# MERSEA HARBOUR PROTECTION TRUST

## Mersea Harbour and Tollesbury Wick Climate Change Adaptation Recharge Project

Response to queries raised by consultees, advisers and the Marine Management Organisation review of licence application MLA/2016/00386

Carol Reid August 2017

Figure 1. Features of historical interest in relation to recharge proposal sites (Jim Pullen).

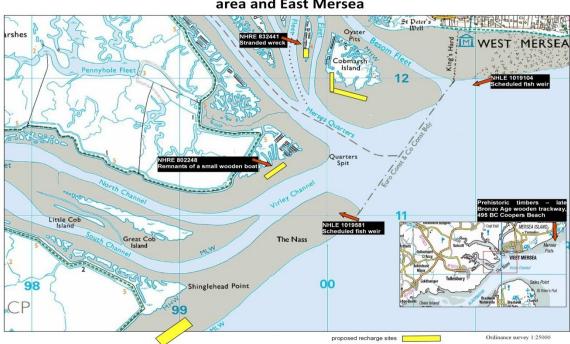
'1.1 Concerns have been raised concerning the level of detail included in the assessment of heritage features. The MMO is, therefore, unable to accurately assess impacts to marine heritage. It is noted that the works are in proximity to multiple designated and undesignated heritage assets. Advice is provided in the sections below concerning sources of information and heritage assists that should be included in an assessment. Further information must be provided to suitably assess the presence of archaeological remains, their significance, likely impacts and proposed mitigation.

1.3 The proposed works areas (including potential anchorage and access routes) are located in proximity to a number of designated and undesignated heritage assets. In particular:

- Two scheduled fish weirs are located in the intertidal zone at West Mersea and Tollesbury Wick in proximity to the recharge sites (NHLE 1019104 and 1019581 respectively).
- A stranded wreck site on Packing Marsh Island (NHRE 832441);
- A wooden hulk on mudflats at Old Hall Marshes (NRHE 802248).

The location of features of historical interest in the Mersea Quarters area and at East Mersea, their distance from the recharge proposal sites, and the potential for the recharge to impact these assets have been fully assessed below and the conclusions are summarised in Table 1. The map shows the position of these artefacts in relation to the recharge (Figure 1).

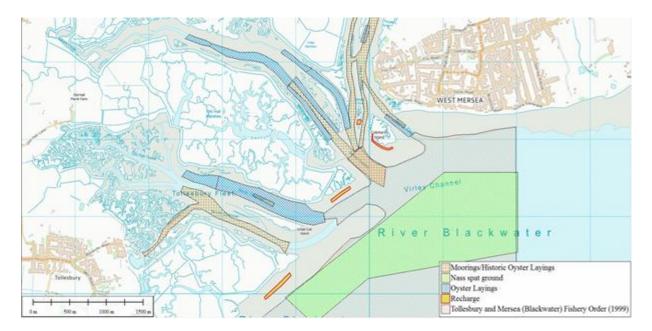
'Section 13.3.4 of ES – Evaluation of Impacts. Impact Identification 2 Page 115. You have stated that turbidity monitoring will be conducted, along with inspection of the oyster beds. Clarification is required as to whether this means further turbidity monitoring or other monitoring. If it is not turbidity monitoring, please provide a methodology for inspection.'

This refers to the monitoring of the commercial oyster beds to account for any settlement of silts during the construction phase. The oystermen who own the Several Order and private oyster layings in the creeks (Figure 5) will advise the MHPT if sediment build-up in the oyster cultivation areas is being observed above the upper range normally encountered in the estuary. Silt levels can vary dramatically in the Blackwater Estuary depending on wind strength and direction: the combination of a high tide and an easterly wind can increase the concentration of silt in suspension from a background level of 50ppm to 600+ppm within a 24-hour period. There is no methodology for inspection; the oystermen routinely check the layings and would use their judgement based on their extensive experience of managing the oyster beds. The local oystermen are part of the MHPT committee and instigated the recharge project to assist in protecting their fishery.

**Figure 6.** Plan diagram showing proposed recharge placement locations [Jim Pullen, 2014; (c) Crown Copyright OS opendata 50k vector mapping 2015 - OS 50k Great Britain 2013]. This is Figure 4 in the ES.

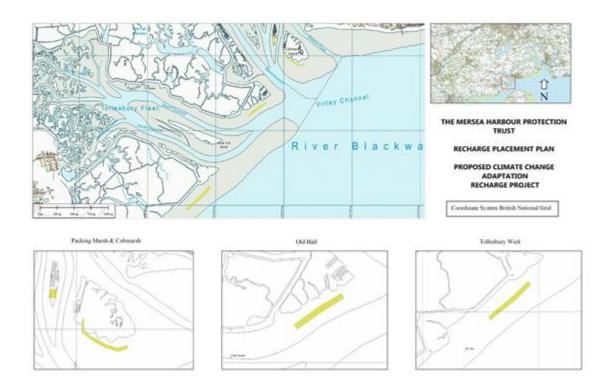
'5.2. Also required is details of any impacts on commercial fishing activities and proposed mitigation to ensure access to vessels, vehicles, moorings and landings will be maintained.'

The map in Section 3.2 of the ES shows the location of the recharge sites in relation to the mouth of the Blackwater Estuary, and the map in Section 1.2 provides a wider view of the estuary mouth and Bradwell-on-Sea. These are reproduced below (see Figures 6 & 7). The operation of the dredger, as described in the ES, at the locations shown in Figure 6 would have a **negligible** impact on commercial fishing activity.

**Figure 8.** Indicates the landing jetty at West Mersea (red arrow) and the mooring areas (the sites of old oyster layings). Adapted from Figure 66 of the ES (Carol Reid). (Jim Pullen. Source: OS Vector Map District 1:50000.)

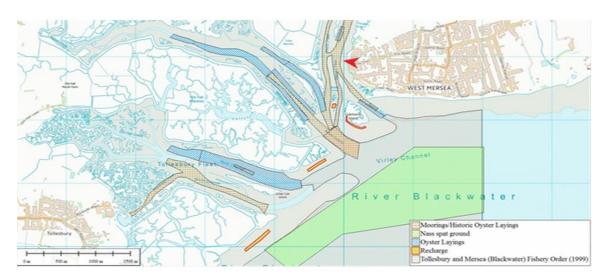
MMO: '5.2. Also required is details of any impacts on commercial fishing activities and proposed mitigation to ensure access to vessels, vehicles, moorings and landings will be maintained.'

All access, disembarkation, and landings of catch occur via the landing pontoon on the Strood Channel in Mersea Harbour, to the west of West Mersea village. There are moorings in the creeks around Cobmarsh Island - in the Besom Fleet to the east of Cobmarsh, and Mersea Fleet, between Cobmarsh and Packing Marsh Islands. The fairway to the west of Packing Marsh Island, Thorn Fleet, contains moorings. There are also moorings in the Salcott Channel, south of Packing Marsh Island and east of Old Hall, and in the upper South Channel, which lies to the north of Tollesbury Wick (refer to Figure 7, above, and Figure 8 below).

The dredger will be delivering material at high tide over a 40-minute period. It would not prevent access to moorings or landings to the pontoon. There are no moorings or landings directly in the vicinity of the recharge proposal sites at Old Hall and Tollesbury Wick, and craft entering or leaving the South Channel, located between these two sites, would not be restricted. All of the recharge sites are located in the outer harbour. The alignment of the vessel while discharging would not prevent passage through the navigable channels. There will be no restriction to vehicle access as there is no shore-based work associated with the delivery of the dredgings. It is concluded that the impact will be of **no significance** regarding 'vehicles' and will be of **negligible** significance to vessels, moorings and landings.
